KBSO Project #: 24023
Project Name: Noblesville HS AHU Replacements – Bid Pack 2
Issue Date: 10/10/2024

This Addendum number 1 to the drawings and specifications shall supplement, amend, and become a part of the bidding documents, plans, and specifications. All bids and construction contracts shall be based on these modifications to the original contract documents.

3 AHU-20 DEMO SECTION
1/4" = 1'-0"

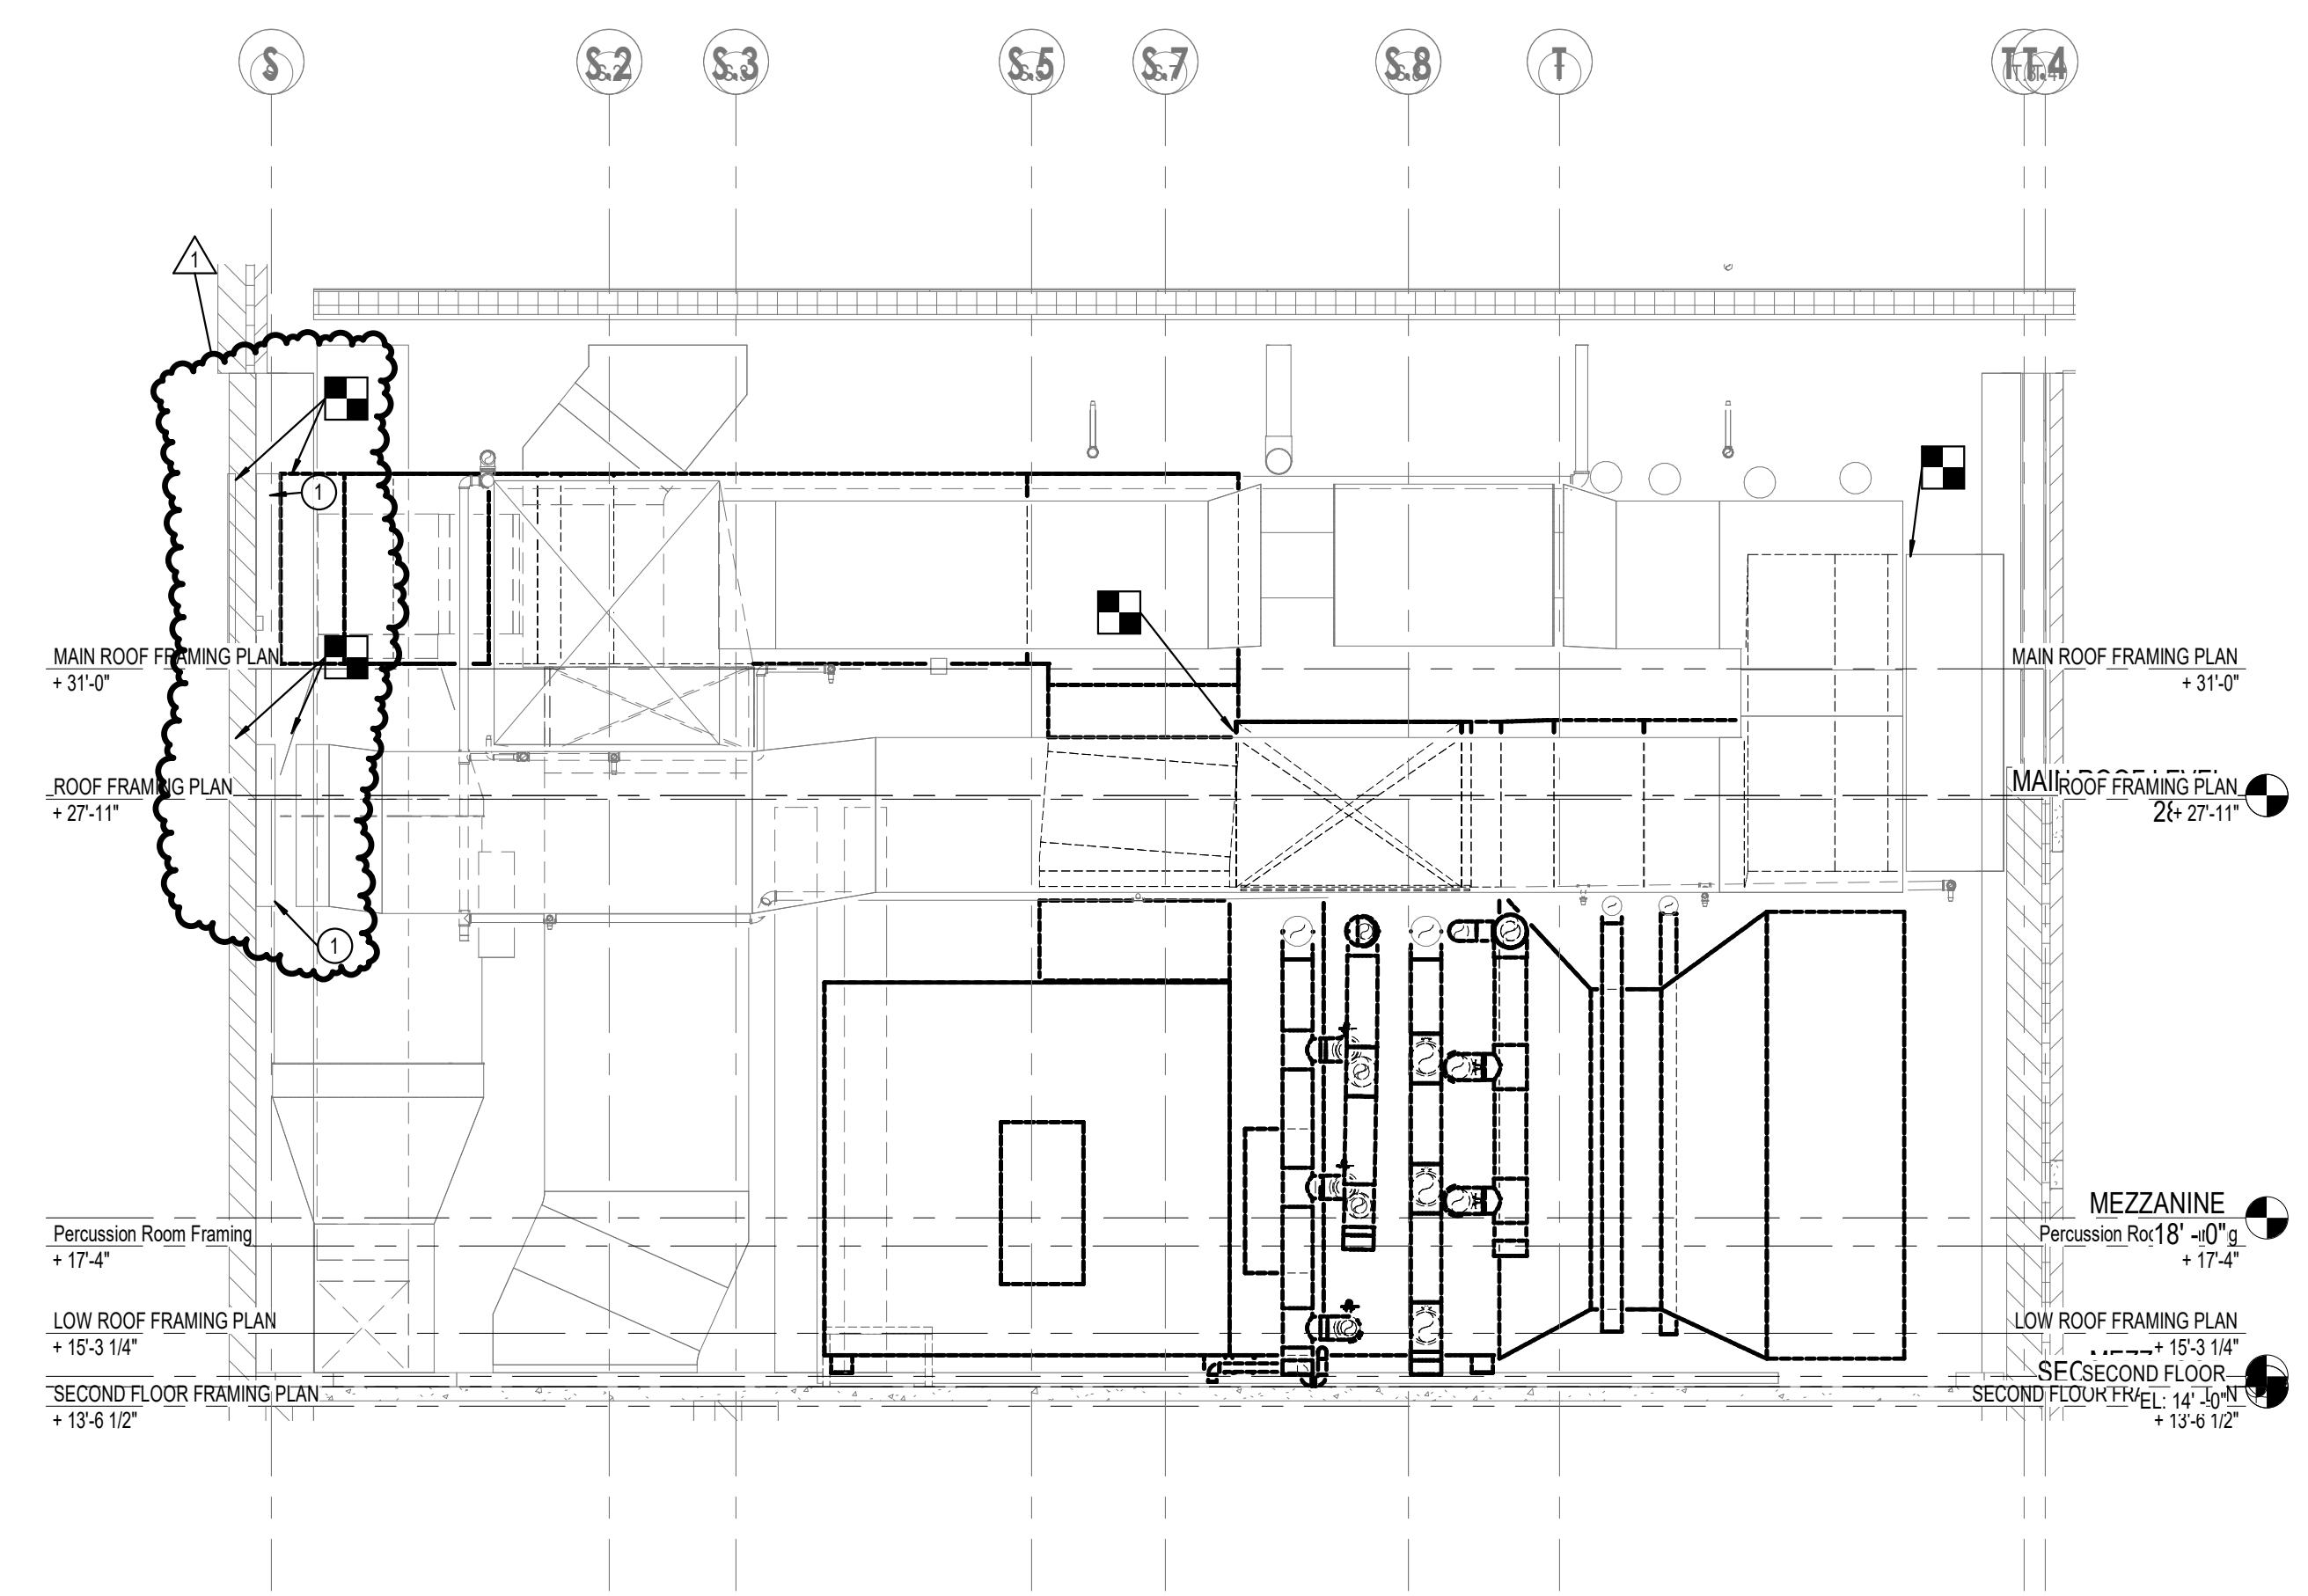
- 3.01 M521 - MECHANICAL DETAILS
 - a. See revised drawings with revision clouds included
- 3.02 M621 - MECHANICAL SCHEDULES
 - a. See revised drawings with revision clouds included
- 3.03 M721 - GROUND FLOOR CONTROLS & LOGISTICS PLAN
 - a. See revised drawings with revision clouds included
- 3.04 M722 - SECOND FLOOR CONTROLS & LOGISTICS PLAN
 - a. See revised drawings with revision clouds included
- 3.05 MD321 - MECH RM M11 MECHANICAL DEMOLITION PLAN
 - a. See revised drawings with revision clouds included
- 3.06 MD322 - MECH RM M12 MECHANICAL DEMOLITION PLAN
 - a. See revised drawings with revision clouds included

- 1 REMOVE FIRE DAMPER
